8XC196KC SPECIFICATION UPDATE

Release Date: May, 1997
Order Number: 272834-004

The 8XC196KC may contain design defects or errors known as errata. Characterized errata that may cause the 8XC196KC's behavior to deviate from published specifications are documented in this specification update.

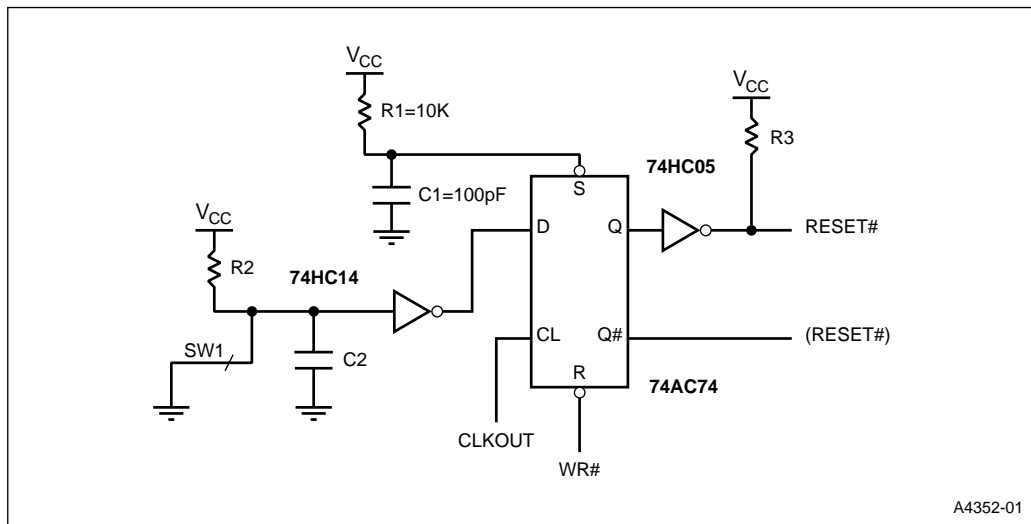
WORKAROUND: Allow reset to occur only at the rising edge of CLKOUT and only if WR# is high. If a reset occurs during an external bus write cycle, RAM data on the external bus may be corrupted. This describes a logic design that will alleviate the problem.

The following circuit will allow a manual reset to occur at the rising edge of CLKOUT only if WR# is high (inactive). If WR# is low (active) then RESET# will stay high (inactive). The 74HC14 and 74HC05 are usually already in the system, so the only additional components are the 74AC74, R1, and C1.

1. R1 = 10K ohms and C1 = 100 pF.
2. R2 and C2 should allow for reset state times plus write wait states.

If software resets can occur, use RESET#. If no software resets will occur, eliminate the 74HC05 and use (RESET#).

The $R1 \cdot C1$ time constant is one microsecond to ensure that the flip-flop comes up 'on' after a power-up. The reset flip-flop at the rising edge of CLKOUT after the $R2 \cdot C2$ time constant has expired.

Figure 1. Options for Decreasing Noise Sensitivity

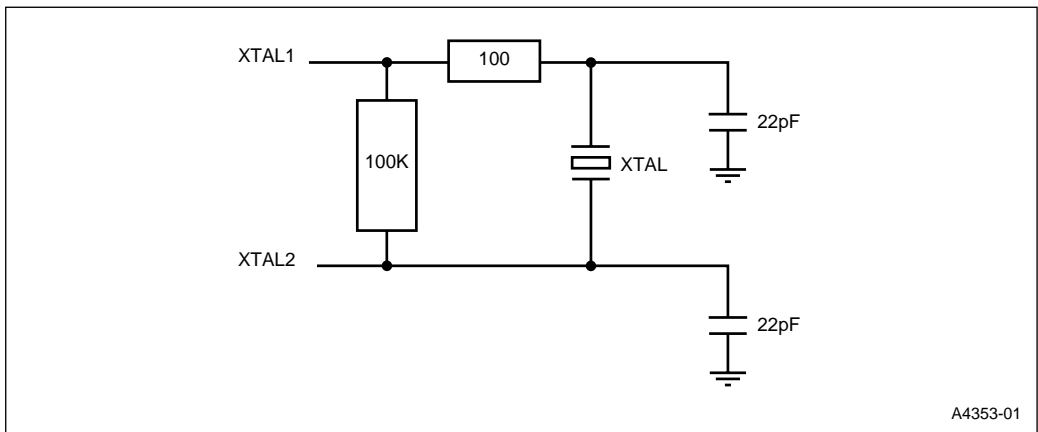
PROBLEM: The oscillator may enter a mode in which the peak-to-peak voltage may not be great enough to consistently trigger the internal clock circuits. This gets worse with ceramic resonators, high temperature, socketed parts, or boards without ground planes.

The oscillator can change from one state to another if there is an appreciable change in the noise level between V_{SS} (core ground) and V_{SS1} (port ground). This could occur at device reset, when changing multiple port lines simultaneously, or when switching relays or other high current devices.

1. Use a crystal instead of a ceramic resonator.
2. Use a multi-layer board with dedicated power planes.
3. Solder the 80C196KC directly to the PC board; do not use a socket.
4. Locate the crystal as close to the device as possible and keep the XTAL board traces less than 1 cm each.
5. Tie V_{SS} and V_{SS1} together through the lowest possible impedance path.

6. Decouple each V_{SS} and V_{SS1} pin to V_{CC} .
7. Place a 100 K resistor between XTAL1 and XTAL2. (See Figure 1.)
8. Place a 100 K resistor in series between XTAL1 and the crystal. (See Figure 1.)
9. Thoroughly test each system over its operating range.
10. Use an external oscillator if possible.

Figure 3.

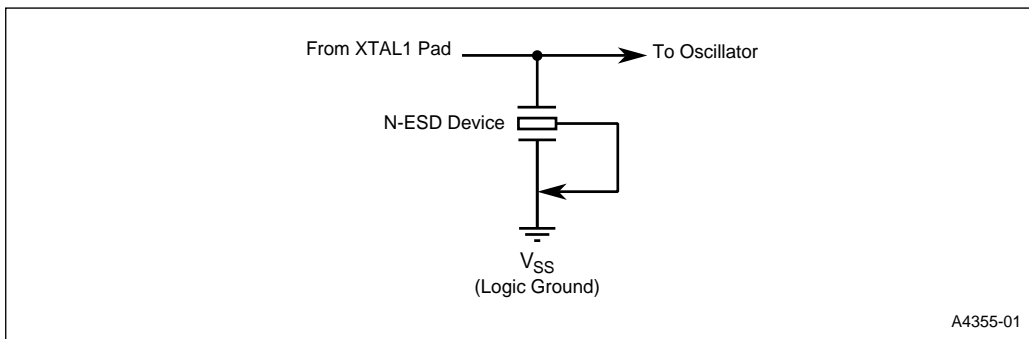
To eliminate the noise sensitivity, the source of the n -channel ESD device is connected to V_{SS} instead of V_{SS1} . The 80C196KC B-3 stepping with a 'C' topside marking implemented

the change in a tape-out in early January, 1991. This is a simple metal mask change that ties both the gate and source of the n -channel ESD device to a common, local ground as shown in Figure 3:

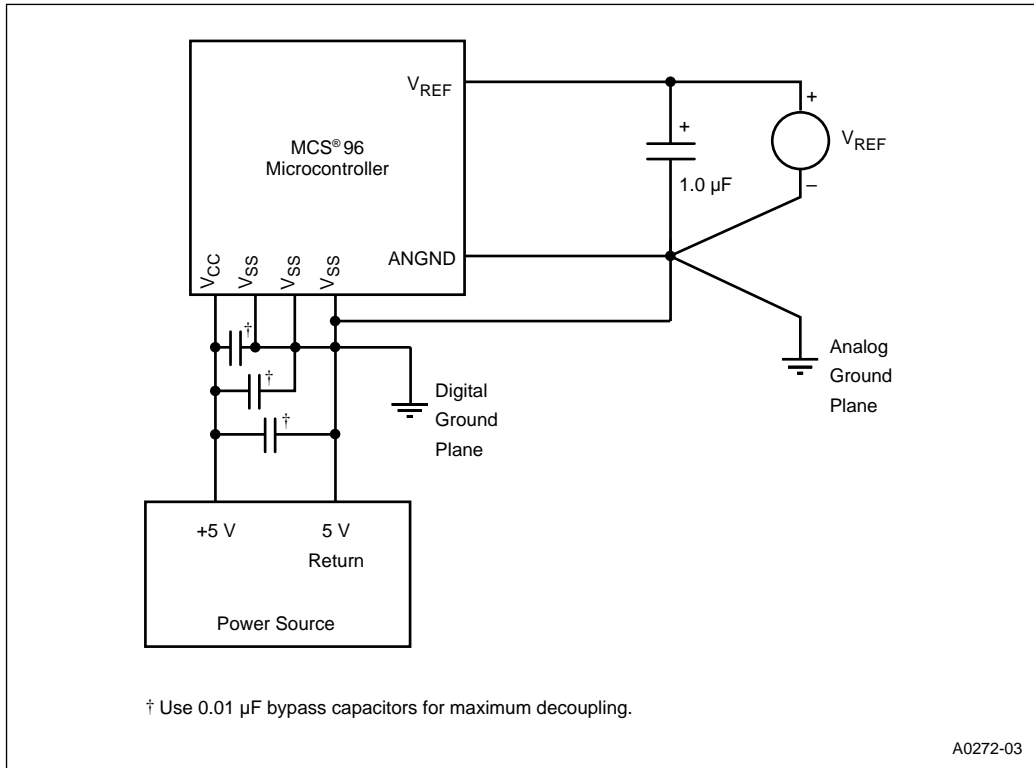
PROBLEM: In Figure 11-2, the recommended capacitor value between V_{CC} and V_{SS} is 0.01 μF or greater. Also the recommended capacitor value between V_{REF} and ANGND is 1.0 μF .

Section 11.2.1 explains the reason for these capacitors. However, the second to last line of the first paragraph should read as follows: 'Connect a 0.01- μF bypass capacitor between V_{CC} and each V_{SS} pin and a 1.0- μF capacitor between V_{REF} and ANGND.'

Figure 4. Serial Port Block Diagram

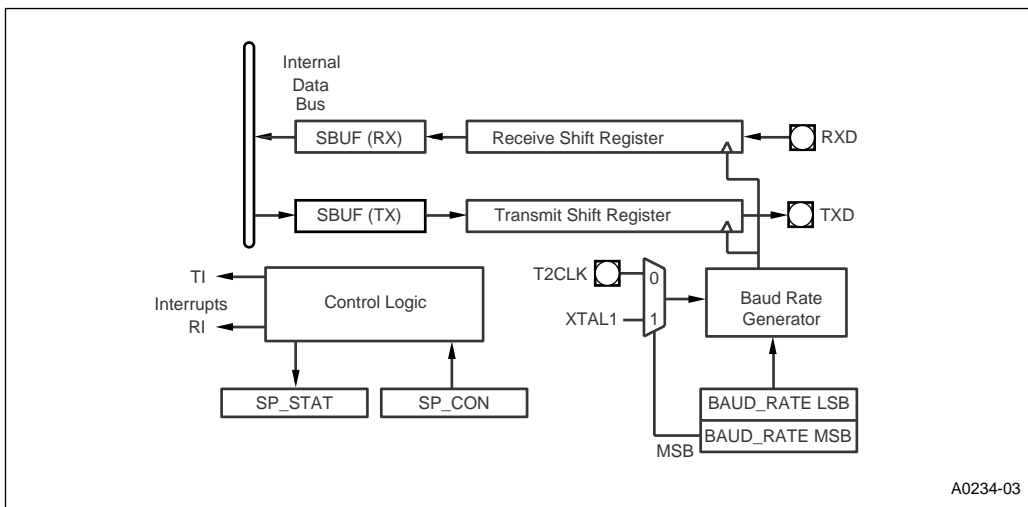
ITEM: The following block diagram will be included in future manuals.

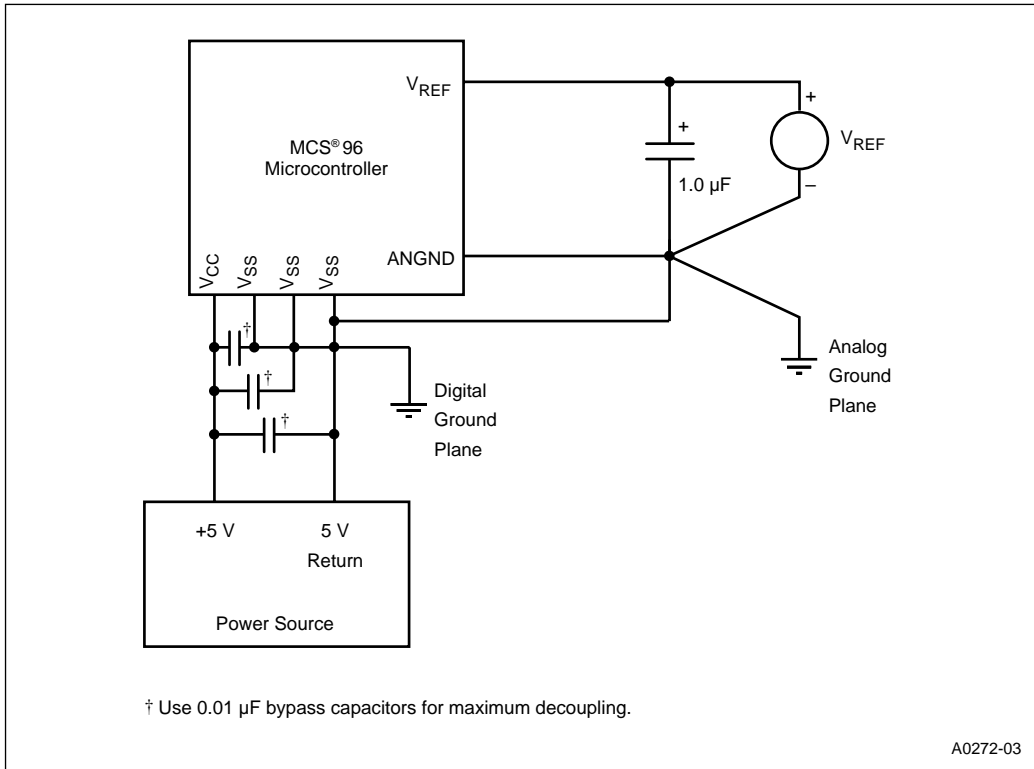
ITEM: On page 10-2, add the following sentences to the second paragraph, after the first sentence: 'Since the value written to the control register is buffered, you can write a new 8-bit value to PWMx_CONTROL before the counter overflows. The new value is used during the next period of PWMx.'

The following figure replaces Figure 10-2.

Figure 11-6. External Clock Drive

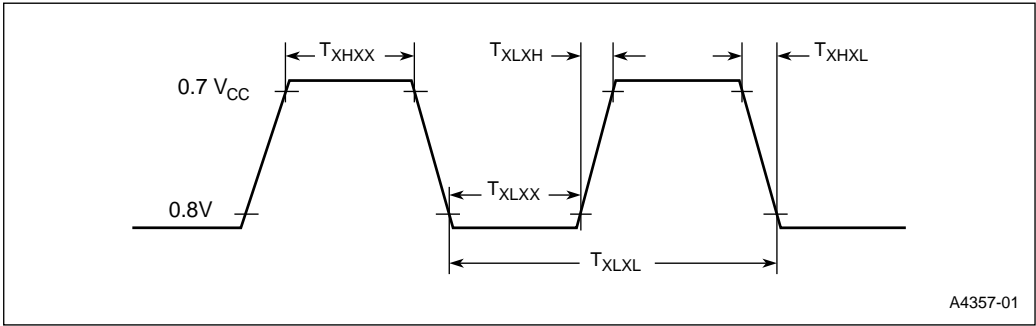
ITEM: In Figure 11-6, the timing diagram incorrectly represents the T_{XLXL} and T_{XHXL} timing specifications. The timing diagram below replaces Figure 11-6.

Figure 11-8. Reset Pin Internal Circuit

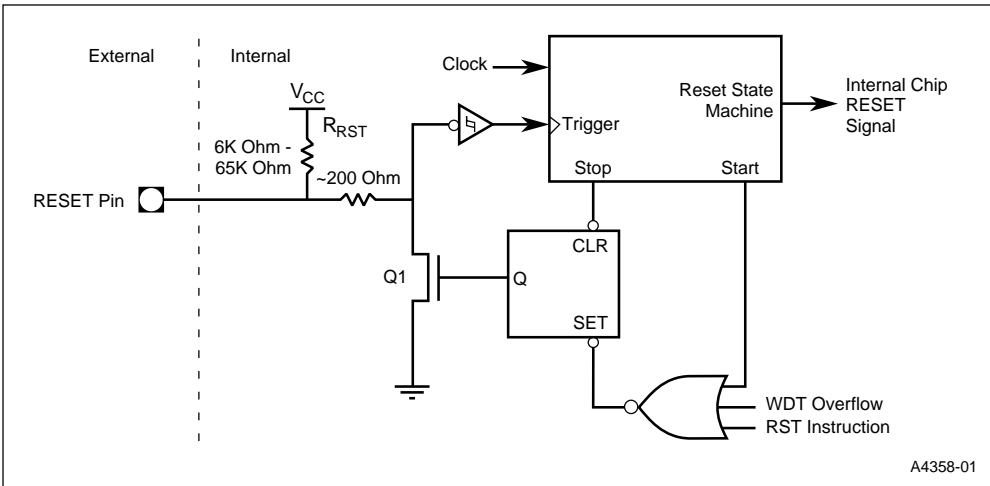
ITEM: Figure 11-8 shows the reset pin internal circuit. However, there are a couple of mistakes; the following figure shows the corrected version. The **inverter** at the Reset State Machine’s Trigger input and the **OR gate** at the SET input of the latch are the corrections to this figure.
